Lintas Bangladesh Co. Ltd

Adamjee EPZ, Siddhirganj
(23.677561, 90.525548)
27th April, 2017

Column layout plan.

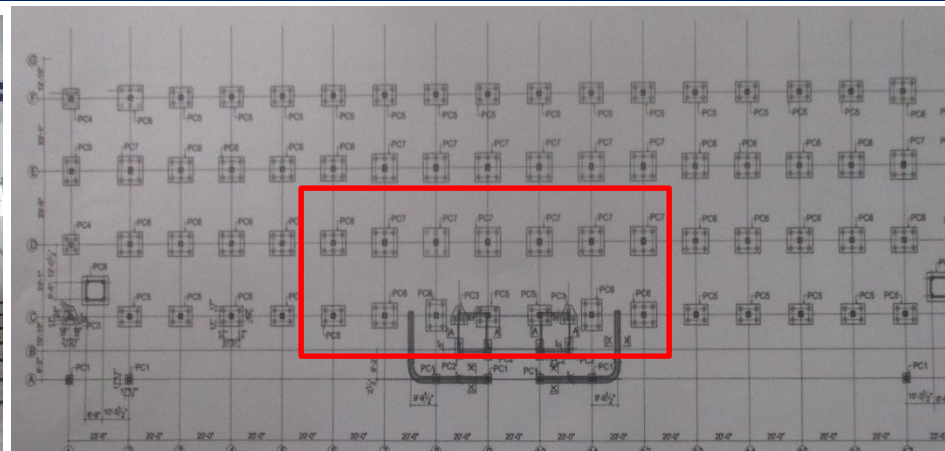
Foundation system of additional columns are required to verify

Additional columns have observed in highlighted area. No foundation system is shown on drawings for those additional columns. So the load path and foundation system of the columns are required to investigate by factory engineer.

Item No.	Observation	Recommended Action Plan	Recommended Timeline
1	Foundation system of additional columns are required to verify	Building Engineer is required to investigate the foundation system of the additional columns. Also load path of the additional columns are required to verify.	6-weeks
2	Foundation system of additional columns are required to verify	Update the drawings considering additional columns.	6-weeks
3	Cracks on façade walls	Building engineer is required to investigate the reason of cracks on façade walls.	6-weeks
4	Cracks on façade walls	Carry out suitable repair works as per investigation report.	6-months
5	Implement floor load management program	Factory is required to implement load management program as per its floor loading capacity.	6-weeks
6	Implement floor load management program	Follow the load plans for all floors of the buildings and make sure that the workers understand the loading requirements.	6-months
